November 18, 2020

RE: Technical Revision 4 – Shores Gravel Mine/Vogl Amendment (Permit M-1998-013), Weld County, Colorado – Comment Response

MINING PLAN

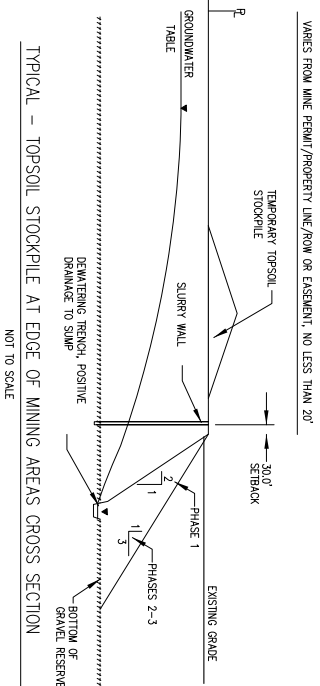
- *Cell 2:* Previously, Cell 2 had been split into two separate cells (2A and 2B) in order to remain to the north and south of the natural drainage. The new plan joins both cells into one 34.1 acre cell (See attached Mine Plan). Cell 2 now extends from the Land Chance Ditch in the south to the northern terminus of the property boundary. Cell 2 will be slurry wall lined and mined out.

- *Cell 3:* Cell 3 (See attached Mine Plan) has been extended slightly further to the north.
- *Slurry Wall:* Two slurry walls will be constructed around the perimeter of individual mining cells (see attached Mine Plan). The west wall will be slightly larger and surround reclaimed Pond 2 and the east will surround Pond 3.

RECLAMATION
PLAN

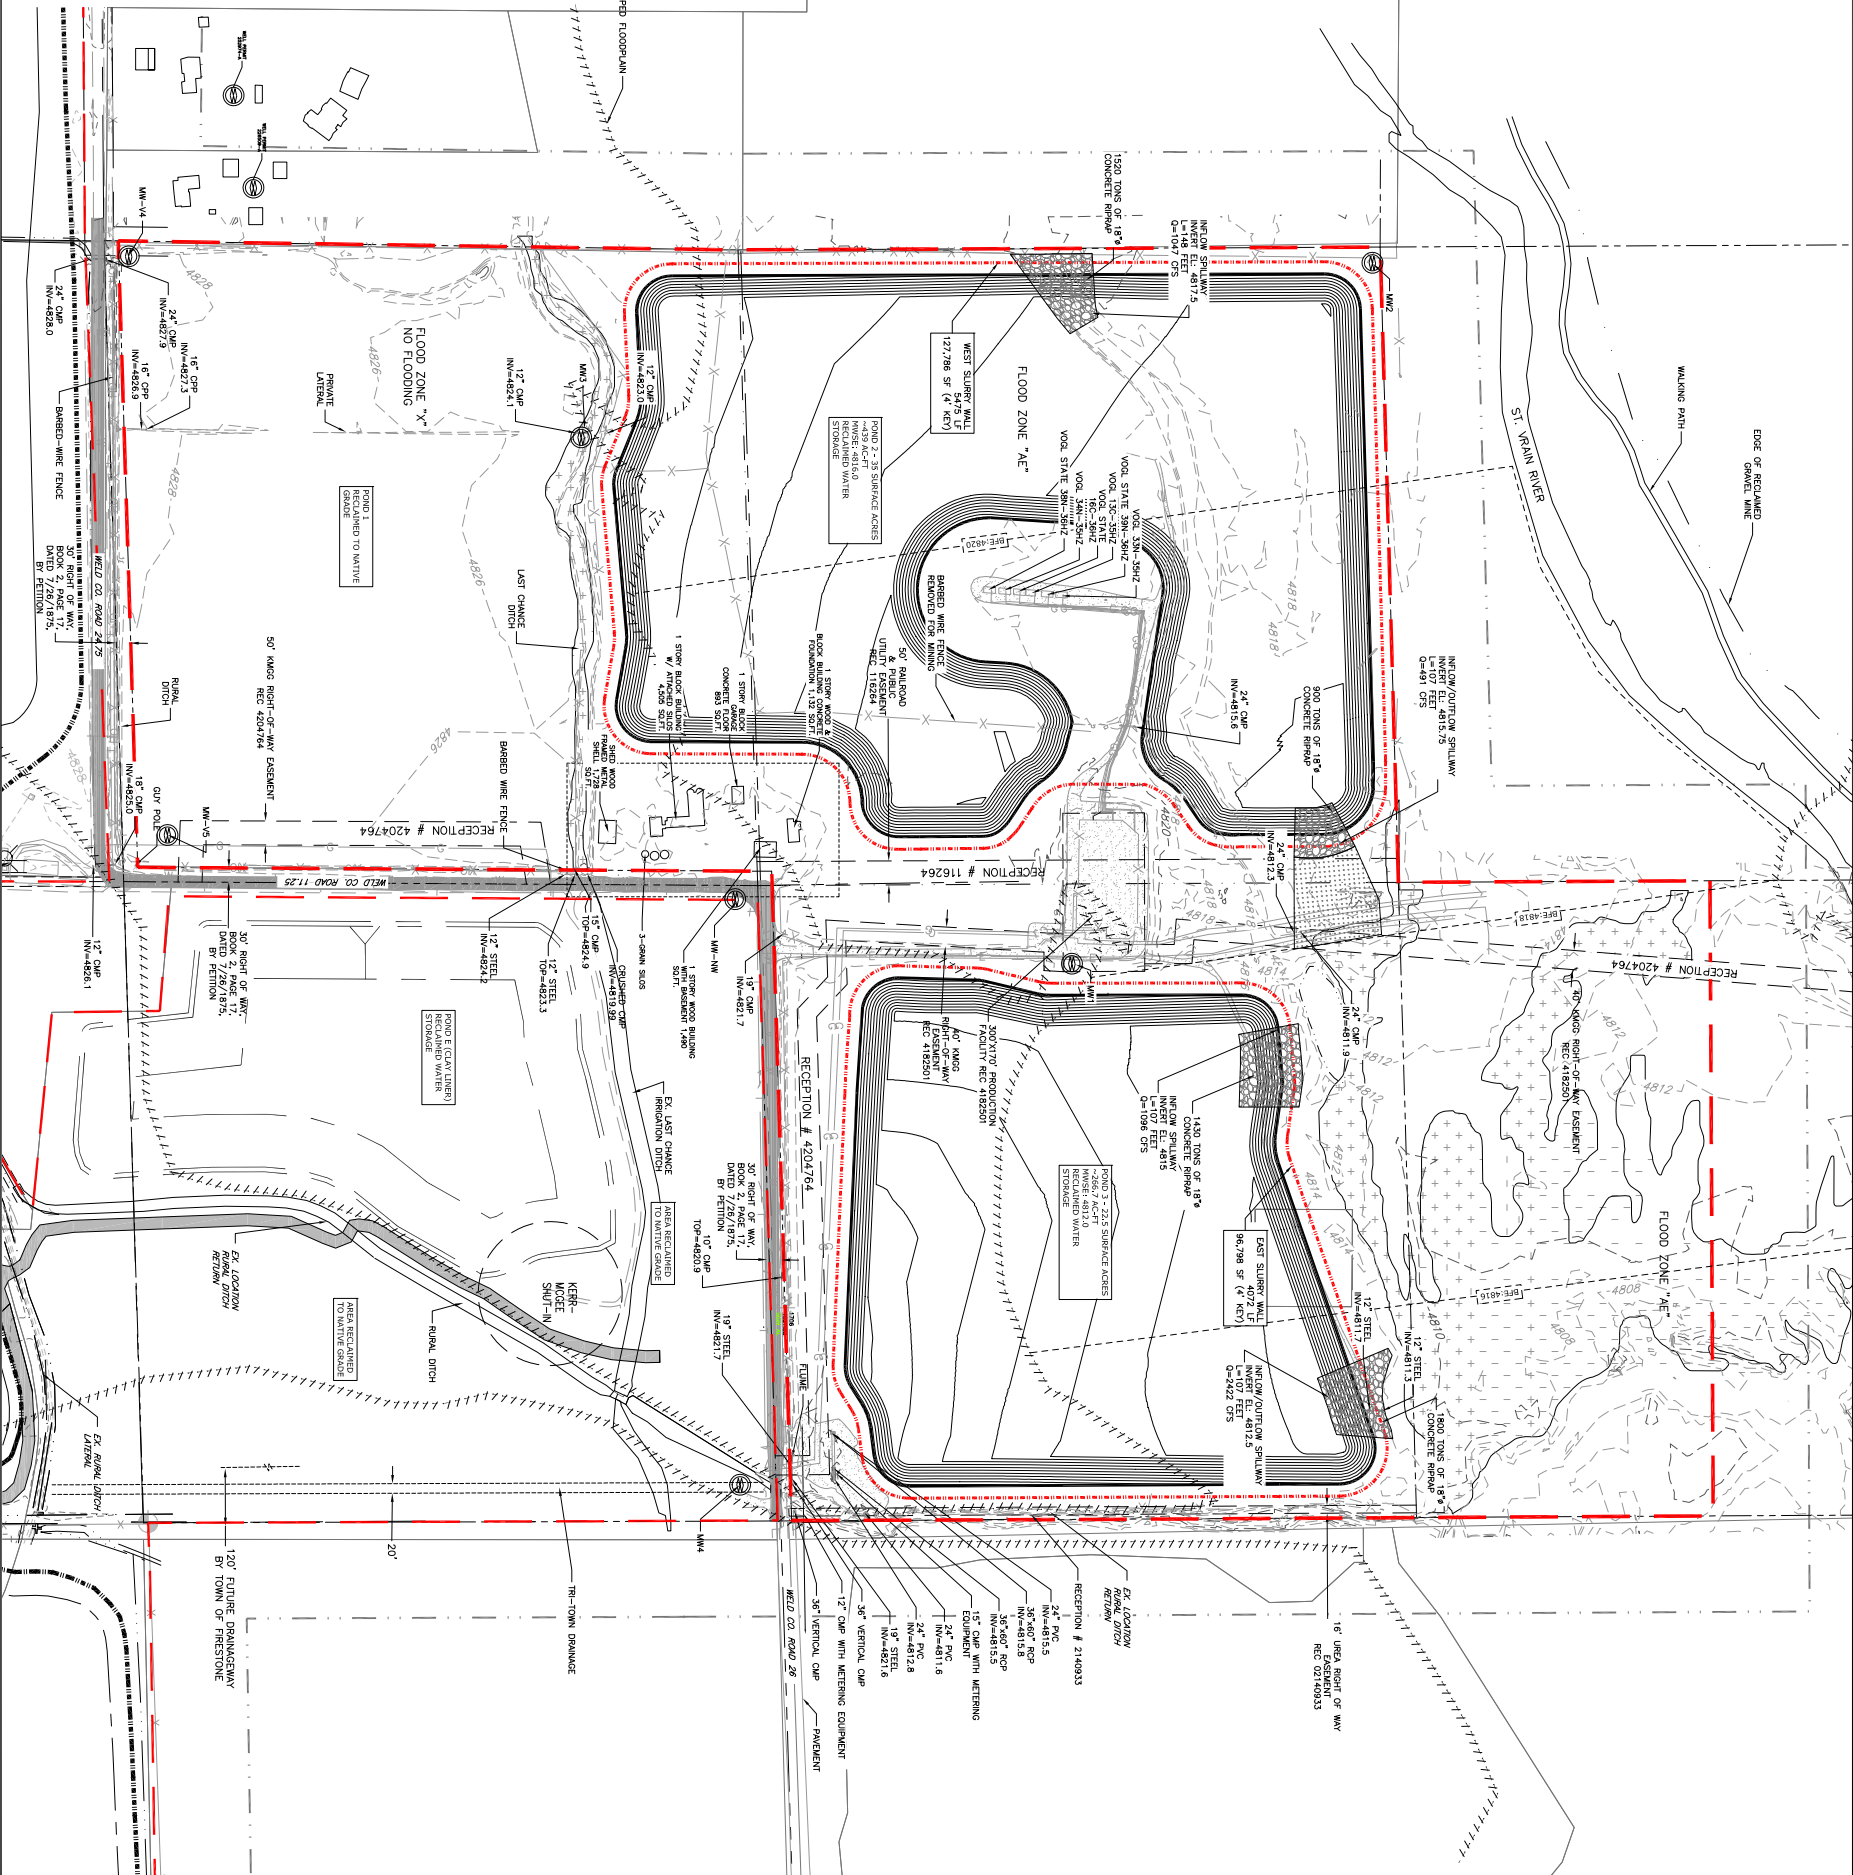
- *Reclamation:* The approved reclamation plan is permitted for a post-mining land use of lined water storage in Pond 2A and Pond 3 while Ponds 2B and 1 were to be returned to native grade. The Technical Revision proposes to combine Ponds 2A and 2B into Pond 2, which will be utilized as lined water storage along with Pond 3 (see attached Reclamation Plan). The mined 3-horizontal to 1-vertical slopes in Ponds 2 and 3 will be

reclaimed at a 3H:1V slope. There are no proposed mining or reclamation changes to Pond 1. Below is a summary of the proposed reclamation for the Vogl site:

- Cell 1 – wet mined and reclaimed as uplands to native grade
 - Cell 2 – slurry lined and dry mined, reclaimed as water storage
 - Cell 3 – slurry lined and dry mined, reclaimed as water storage

The proposed spillway for reclaimed Cell 2 has been realigned to allow flows to enter from the west in the location of the non-jurisdictional drainage and exit at the downstream end of the drainage. Cell 2 has added approximately 100 ac-feet of finished water storage.

Reservoir 2a: 100 percent of reclaimed Cell 2 is within the 100-year floodplain. The following information was considered in designing the spillways and erosion protection:

- The spillway was set on the upstream end approximately two-foot lower than the upstream max water surface elevation, or base flood elevation. This inflow point is the natural low point and will allow for flood waters to fill the pit prior to overtopping.

- The reservoir is approximately 439 acre-feet in volume and the upstream spillway has 1,047 cubic feet per second (cfs) capacity at 2 foot of overtopping depth. The downstream spillway has 491 cfs of capacity at 2 foot overtopping. Each spillway was designed to be able to fill the reservoir so the banks are less susceptible to major washouts. A six-inch per hour rise in flood water would significantly fill the reservoir in approximately 4 hours. This is adequate to protect the non-reinforced banks from severe erosion as the north part of the reservoir would be a minimum of 40-percent full by the time the banks would overtop and potentially erode.

- The reservoir will also be equipped with a discharge spillway at the downstream low point. The discharge spillway will help direct flow as flood waters recede and limit erosion to localized areas. The outflow spillway will potentially serve as an inflow point in conjunction with the upstream spillway depending on how the flood waters rise in the vicinity of these pits.

Reservoir 3: 100 percent of Reservoir 3 is within the 100-year floodplain. The configuration of the reclaimed Cell 3 has changed very slightly and the spillways have not significantly changed. The following information was considered in designing the spillways and erosion protection:

- An inflow and outflow spillway was placed on the north side of Reservoir 3. This spillways will allow water to flow into the reservoir as the invert elevation will be set in the natural low spot of the reservoir grade and is a minimum of one foot below the base flood elevation.

- The reservoir was also equipped with a discharge spillway at the downstream low point. The discharge spillway will help direct flow as flood waters recede and limit erosion to localized areas. The outflow spillway will potentially serve as an inflow point in conjunction with the upstream spillway depending on how the flood waters rise in the vicinity of these pits.
